BLOCK 136

LAND USE HEARING #2

JANUARY 22, 2015

Flush Log Studies - Revised

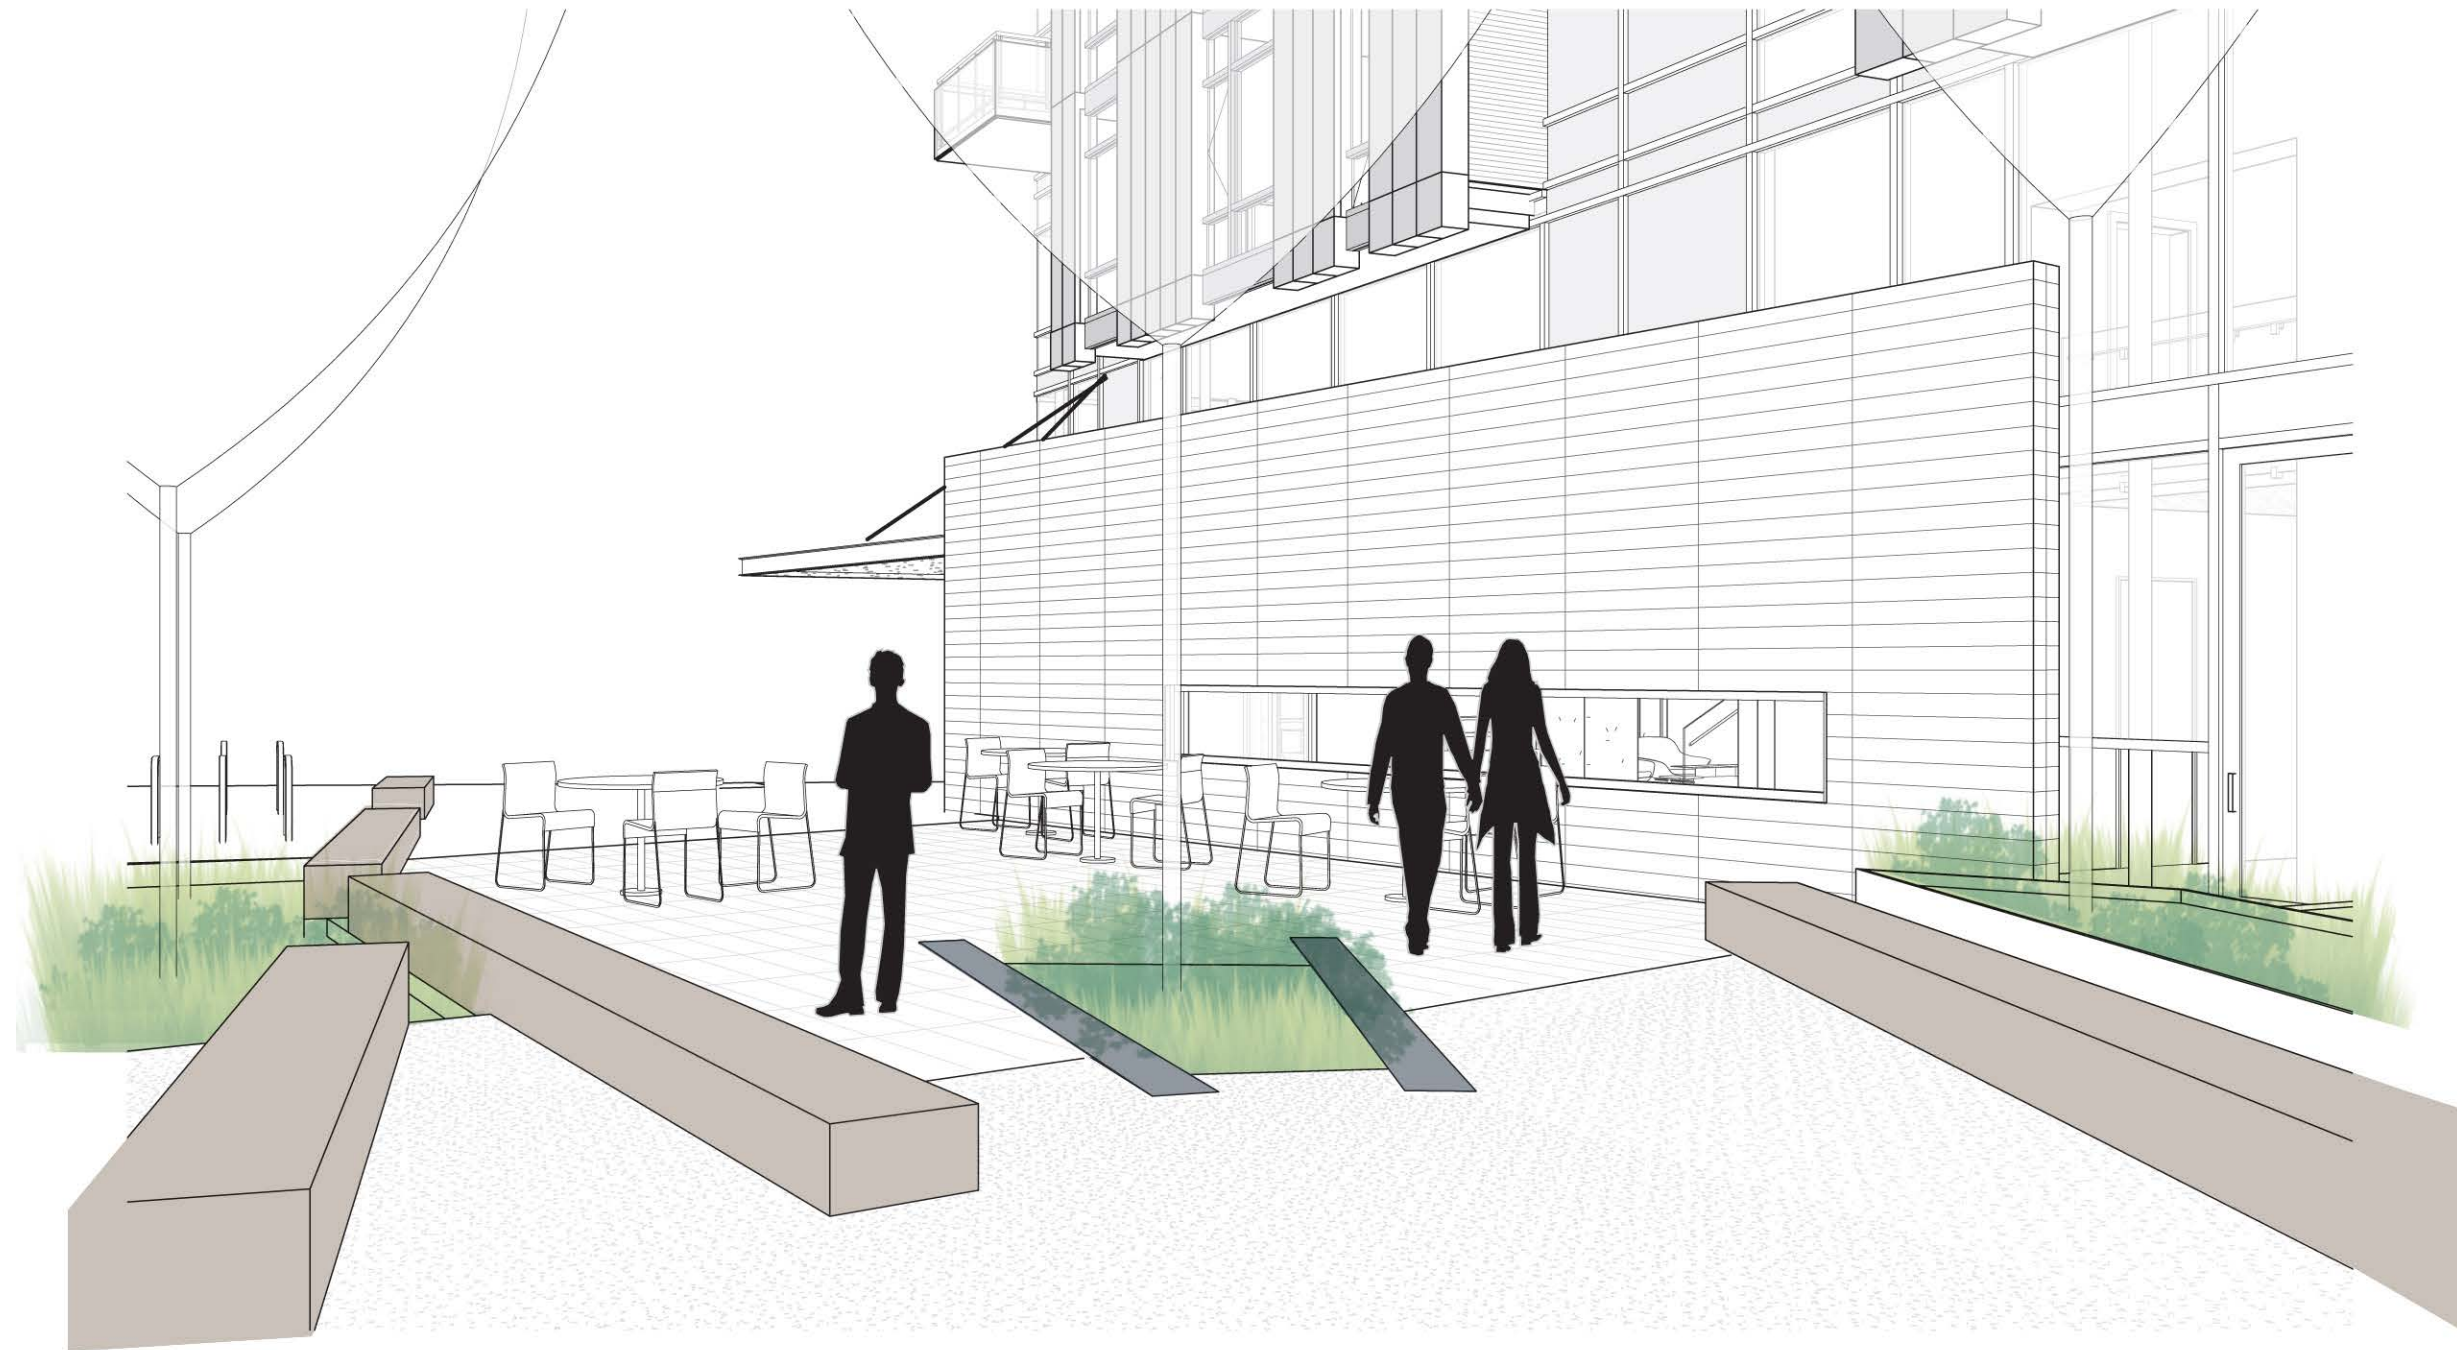
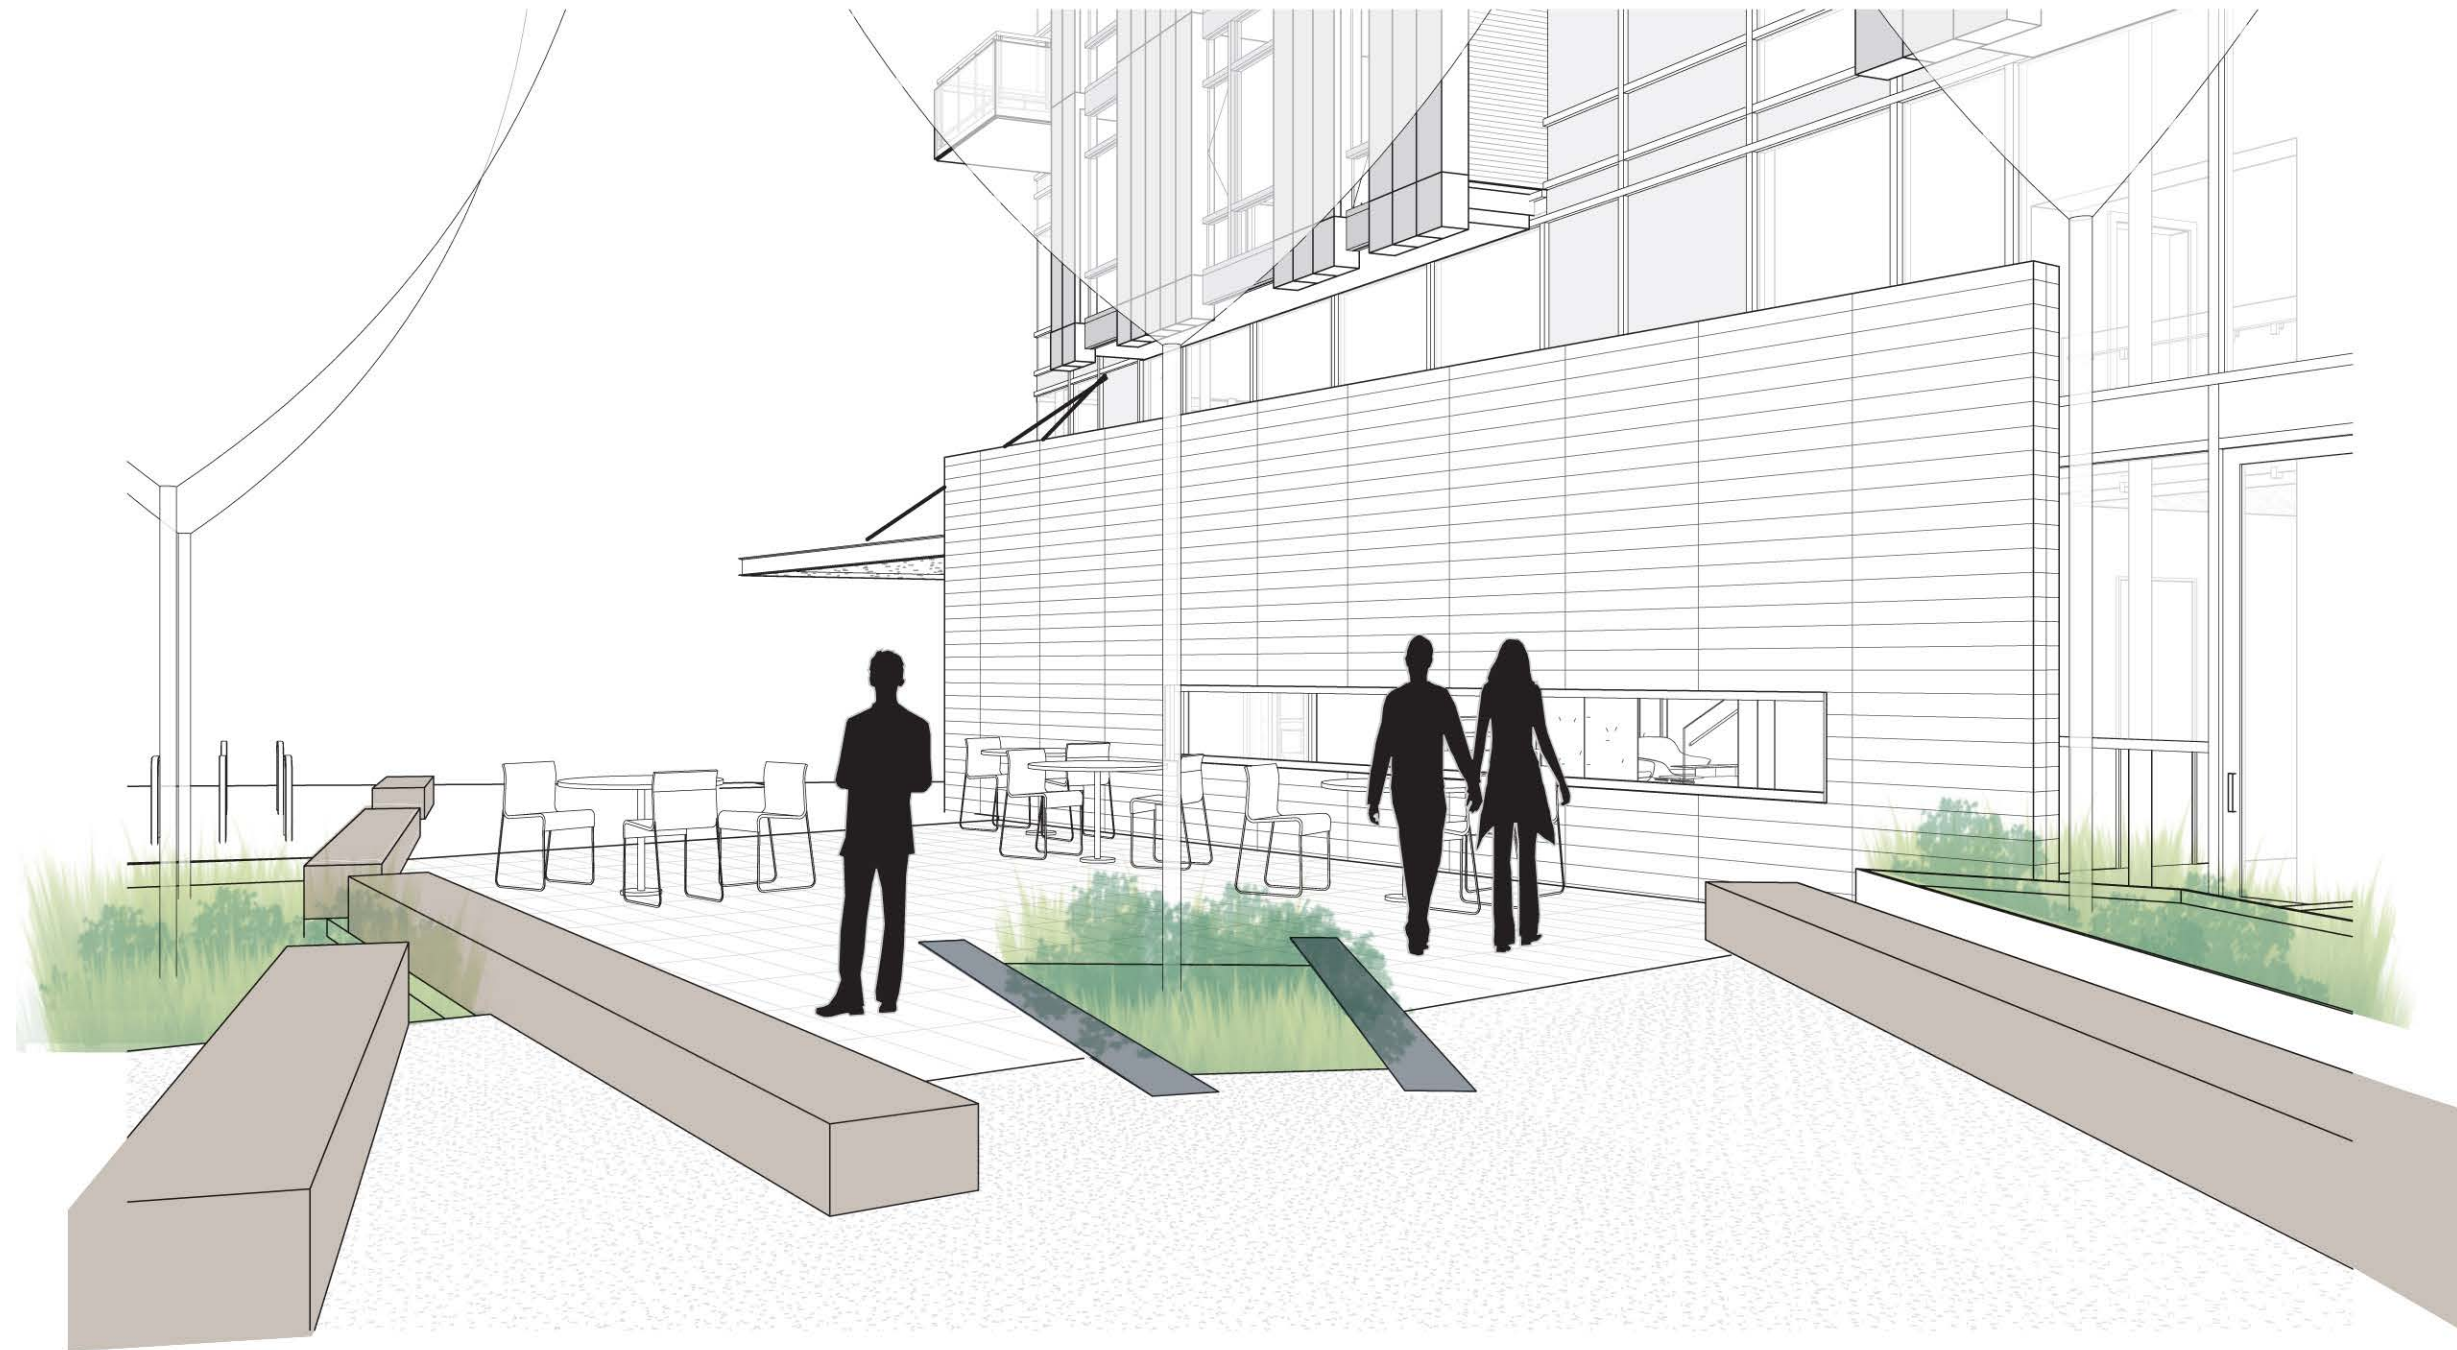
- Study the pinch point
- Detail the flush log so that it isn't slippery
- Detail the connections of the log benches

SE Corner of 12th Avenue - Revised

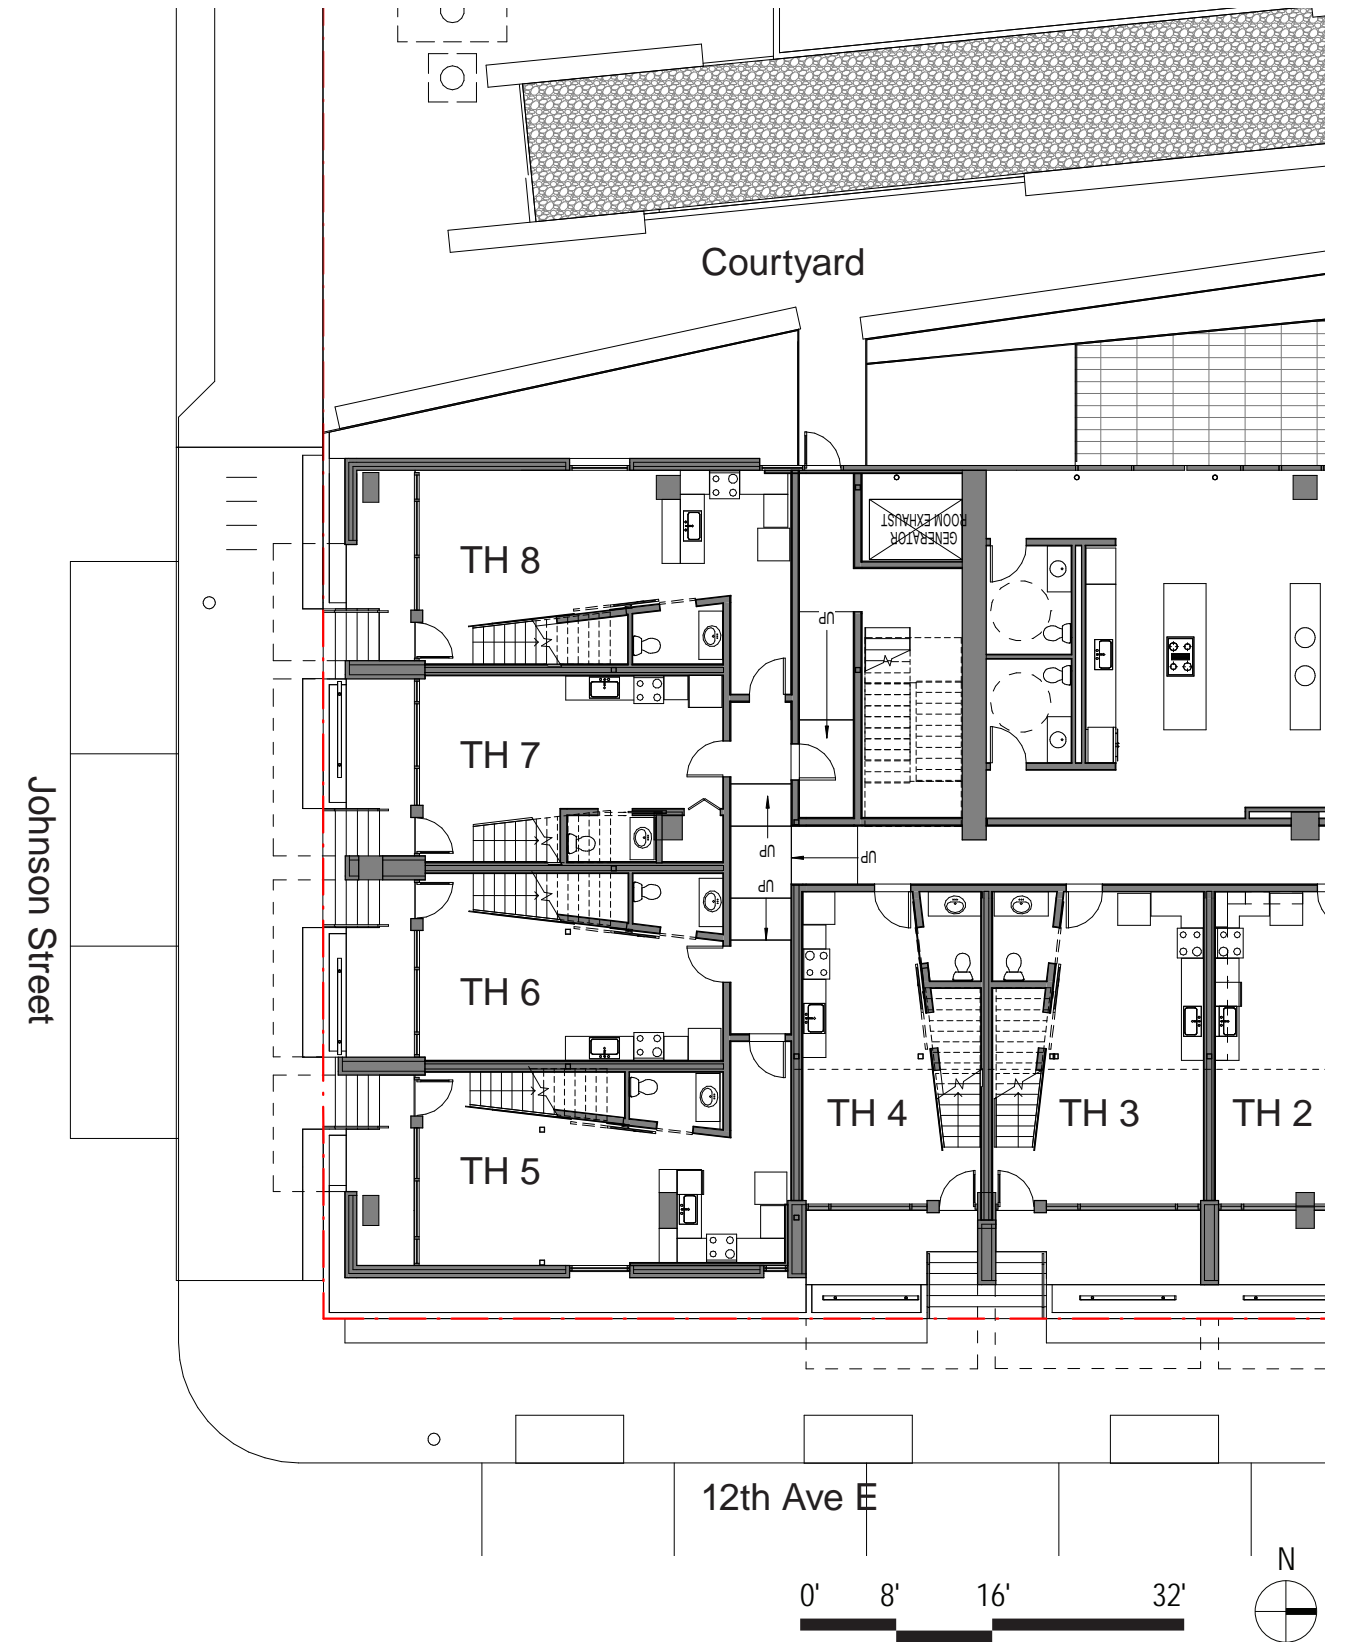
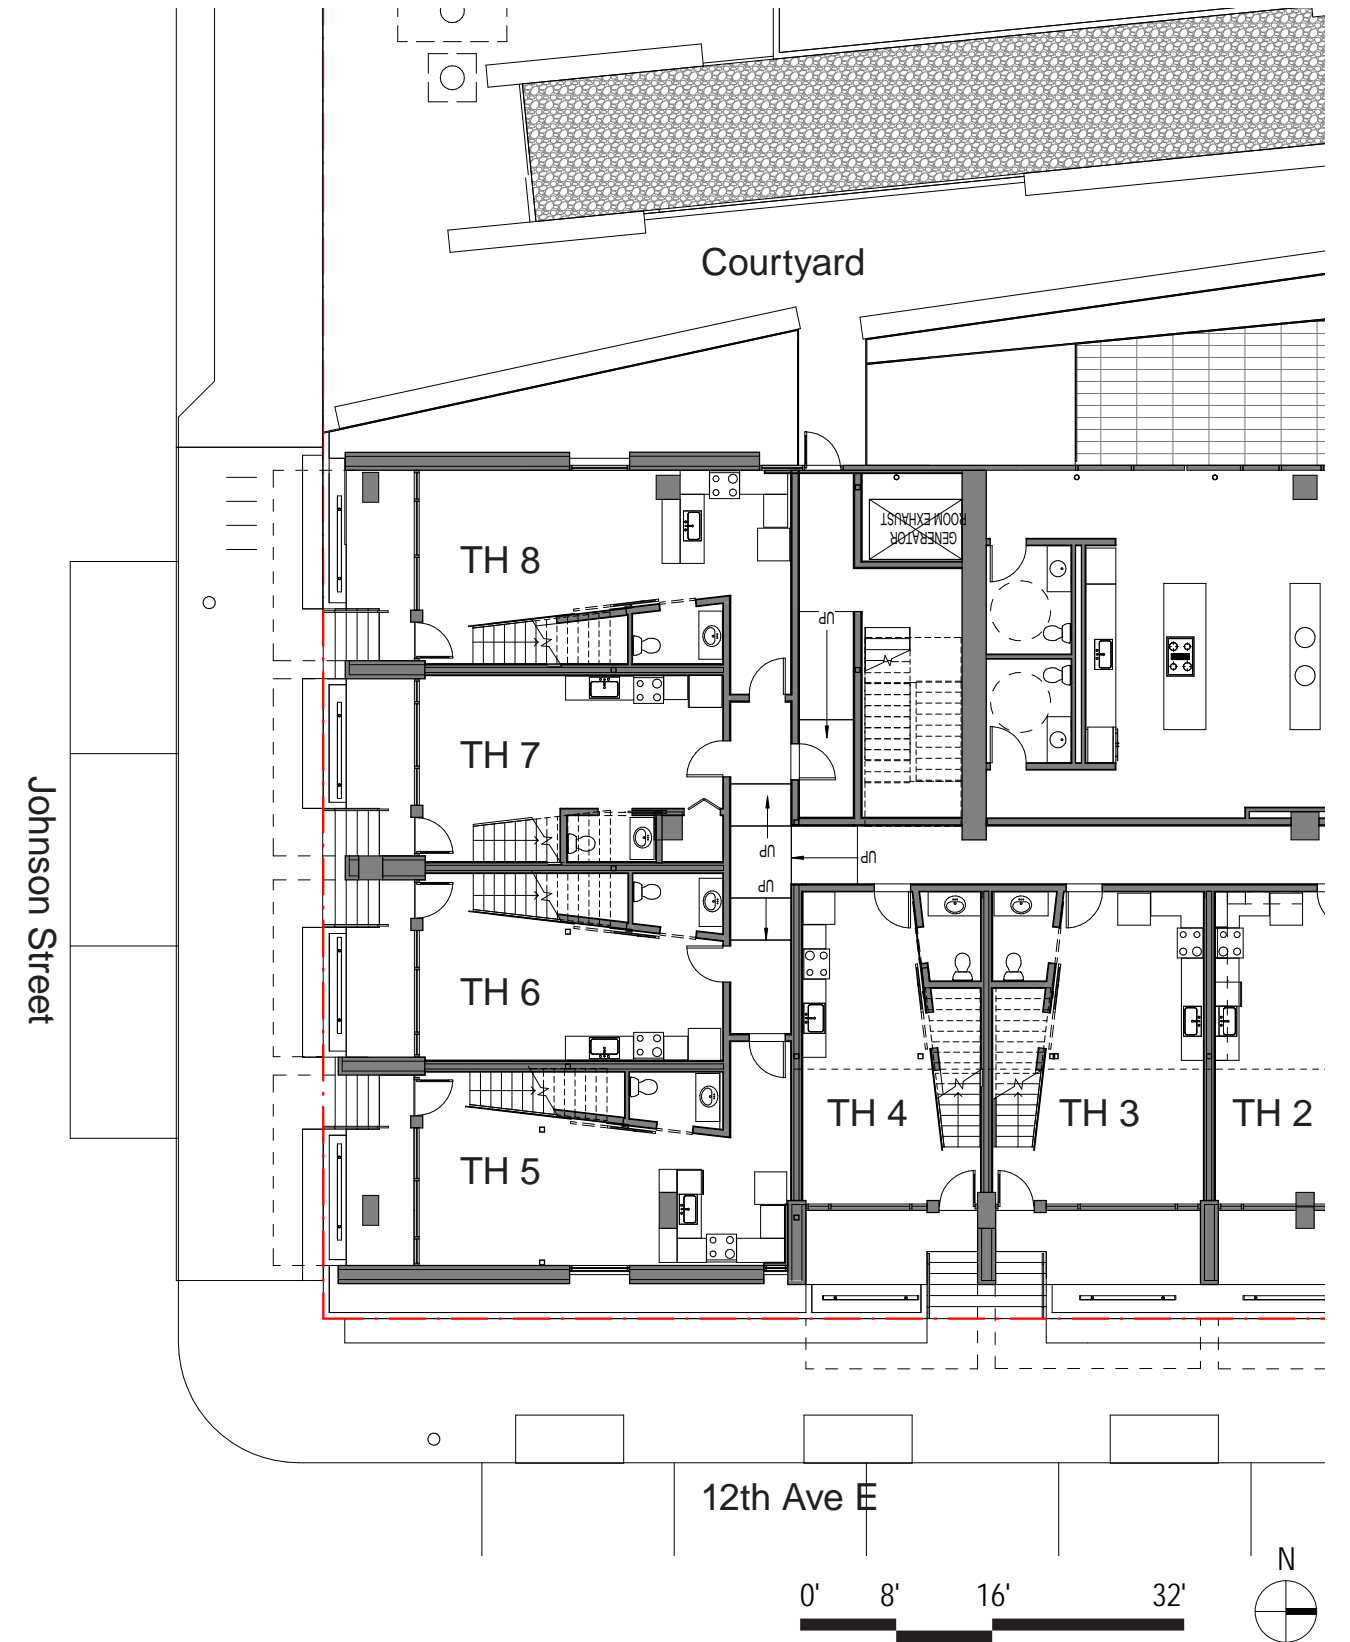
- Study corners at the southeast and southwest
- Add glass to townhouse canopies
- Describe board-formed concrete finish
- Study if residential entry canopy is too low
- Consider increasing the depth of the northern balconies
